Sand Canyon Sewer Relocation Project

Addendum to the Initial Study – Mitigated Negative Declaration

SCH #2024030871

Santa Clarita Valley Water Agency

Figure 3 Modified Project Features – Eastern Extent

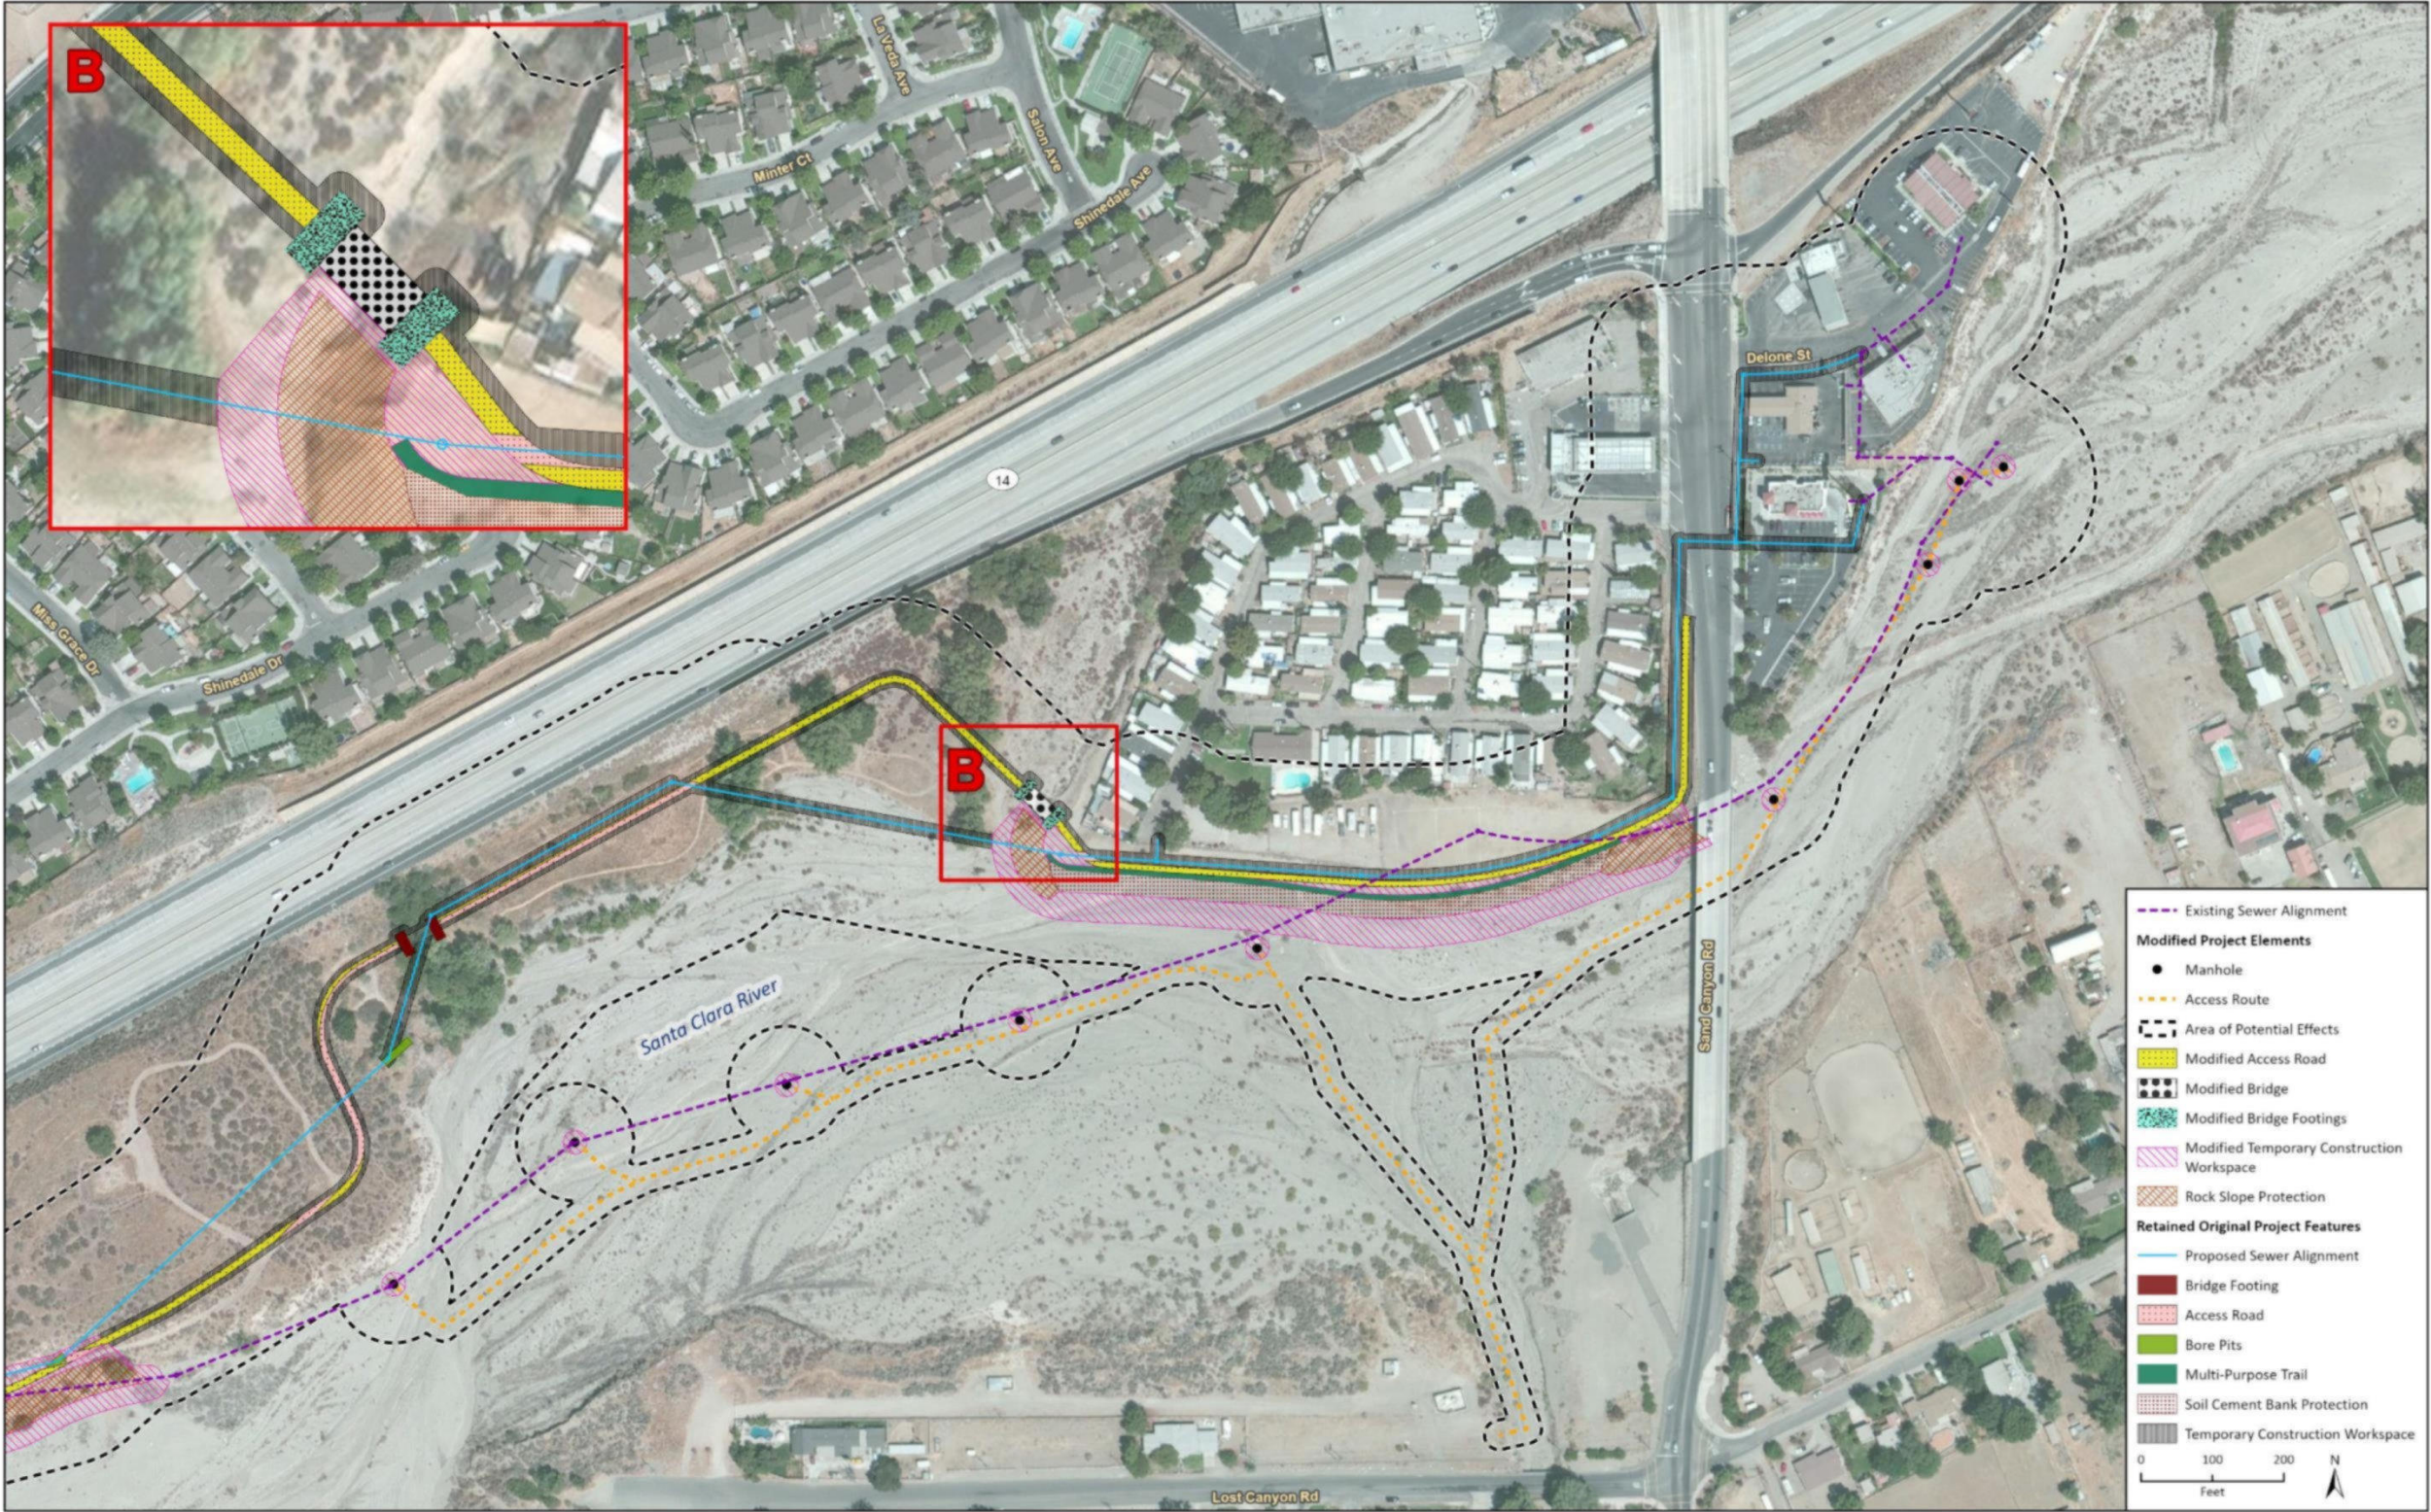
As part of the Modified Project, the permanent access road has been realigned in the area west of the mobile home park. The modified route deviates from the sewer alignment, heading north and then turning west, as shown in Figure 3. Although the APE overlaps with SR 14, the project area is outside of SR 14's right of way and no impacts to SR 14 are expected.

The Original Project included construction of two 16-foot-wide bridges across existing drainage features supported by bridge footings, as described further in Section 2.2. The Modified Project would involve moving one of the bridges and its footings slightly north of where they were planned

to be located under the Original Project. The modified bridge alignment and footing locations are shown in map extent B in Figure 3.
